Recall Bulletin

PRODUCT SAFETY RECALL

SUBJECT: Shift Lever Indicator May Not Display Correct Gear

MODELS: 2008-2010 Chevrolet Malibu
2008-2010 Pontiac G6
2007-2010 Saturn AURA
Equipped with 4-Speed Automatic Transmission (ME7/MN5)

3256032

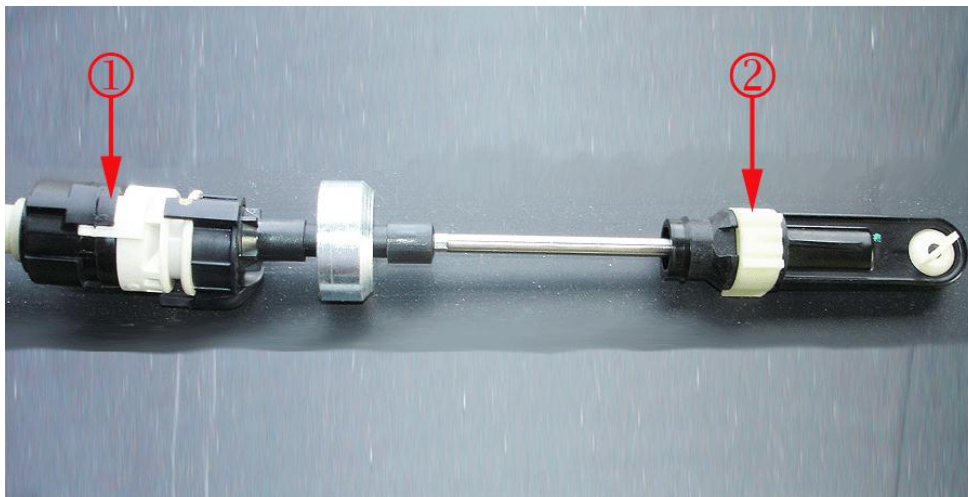
Note: Determine if field action bulletin 09041A has been completed. Inspect the shift cable for the presence of a clam shell cover that surrounds the shift cable locking tabs.

- If the clam shell cover is installed, no further action is required. Refer to the *Warranty Transaction Information* section of this bulletin. Submit a transaction using labor code V2743.
- If the clam shell cover is NOT installed, determine if the transmission shift cable is a first or second design cable.

2269489

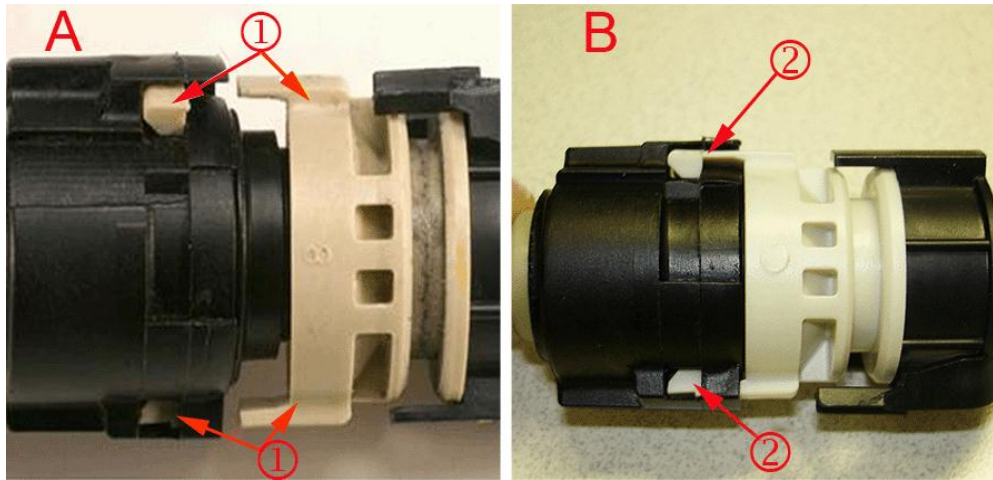
- (1) Shift Cable Locking Tabs
- (2) Shift Cable Adjuster Locking Clip

1. Open the hood and locate the transmission shift cable.

2269486

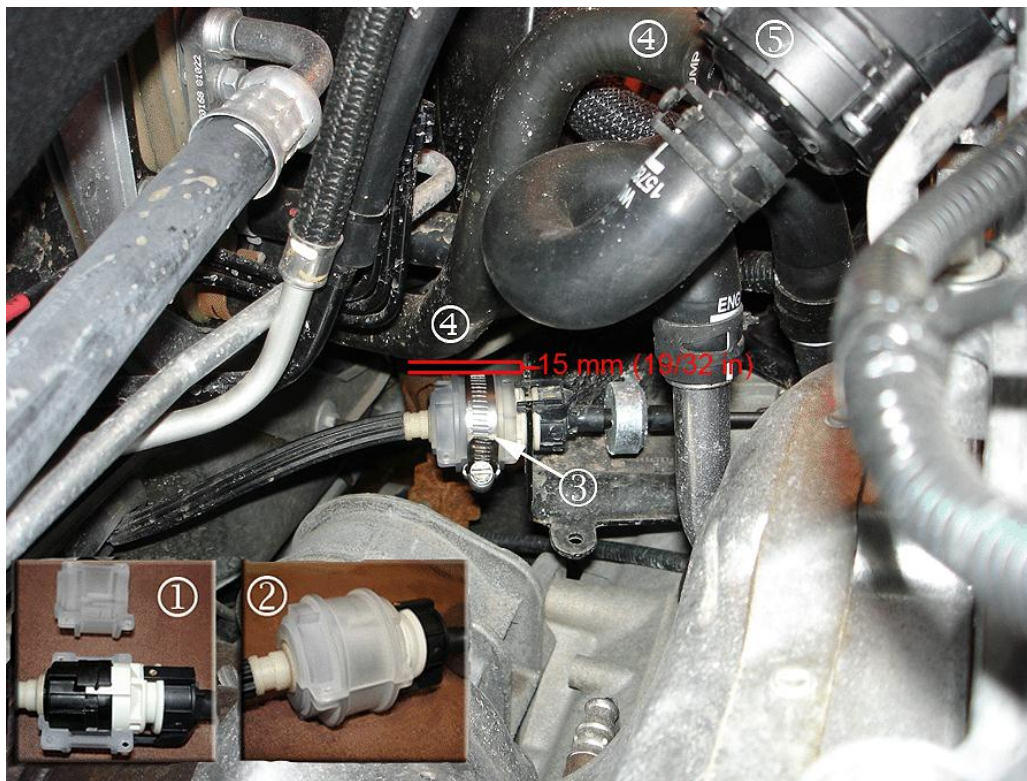
2. Determine if the transmission shift cable locking tabs are fractured and separated.

- If the transmission shift cable locking tabs (1) are fractured and separated (A), remove the transmission shift cable and replace it with a new one. Refer to *Floor Shift Control Cable Replacement or Range Selector Lever Cable Replacement* in SI. **Also install a transmission shift cable kit with the new shift cable.**
- If the transmission shift cable locking tabs (2) are NOT fractured and separated (B), install the transmission shift cable kit. Proceed to Step 3.
